# Access Compliance Report

## Public Rights-of-Way

Intersection ID: 17738	Main Street: CORDER_DR	Cross Street: WINCHELSEA_DR	Location: NE
ADA ID: 107FE91519EC	Ramp Type: PerpDiag	Initial Pass/Fail: Fail	Overall Compliance: No
			Severity Score: 26.25

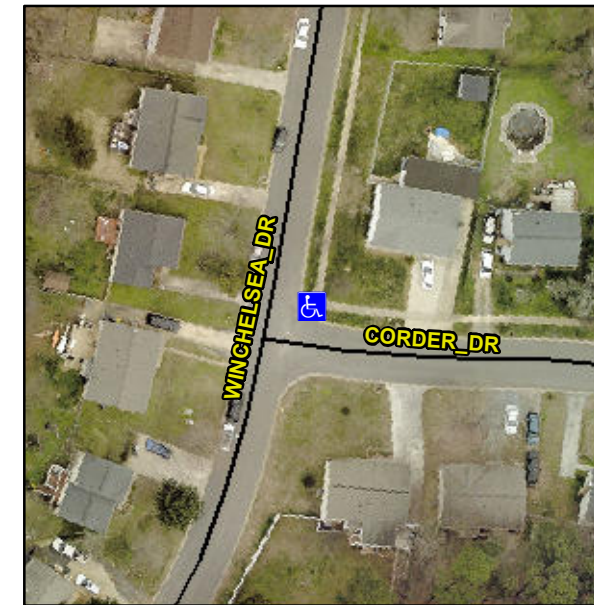
**Not Found, R304.2.2, R304.5.3**

Compliance	Description	Data	Compliance	Description	Data
N/A	Ramp Length (in)	46.0	No	Ramp Slope (%)	13.7
Yes	Ramp Width (in)	48.0	No	Ramp XSlope (%)	2.6
N/A	Flare Type LT	N/A	N/A	Flare Type RT	N/A
N/A	Flare Slope LT (%)	N/A	N/A	Flare Slope RT (%)	N/A
N/A	Flare Traversable LT?	N/A	N/A	Flare Traversable RT?	N/A
N/A	Landing Length (in)	N/A	N/A	DWS Provided?	N/A
N/A	Landing Width (in)	N/A	N/A	DWS Contrast?	N/A
N/A	Landing Slope (%)	N/A	N/A	DWS Length (in)	N/A
N/A	Landing X Slope (%)	N/A	N/A	DWS Full Width?	N/A
N/A	Landing Curb? (Y/N)	N/A	N/A	DWS Offset (in)	N/A
N/A	Shared Landing?	N/A			
N/A	Gutter Ponding?	N/A	N/A	Gutter Slope (%)	N/A
N/A	Gutter Lip Ht (in)	N/A	N/A	Gutter X Slope (%)	N/A
N/A	Painted X Walk1?	No	N/A	Painted X Walk2?	No
	X Walk 1 Direction	To SW		X Walk 2 Direction	To NW
N/A	X Walk 1 Width (in)	N/A	N/A	X Walk 2 Width (in)	N/A
	X Walk 1 Slope (%)	2.5		X Walk 2 Slope (%)	2.2
	X Walk 1 X Slope (%)	1.6		X Walk 2 X Slope (%)	2.8

**Remove & Replace Curb Ramp With Two New Directional Ramps or Equivalent.**
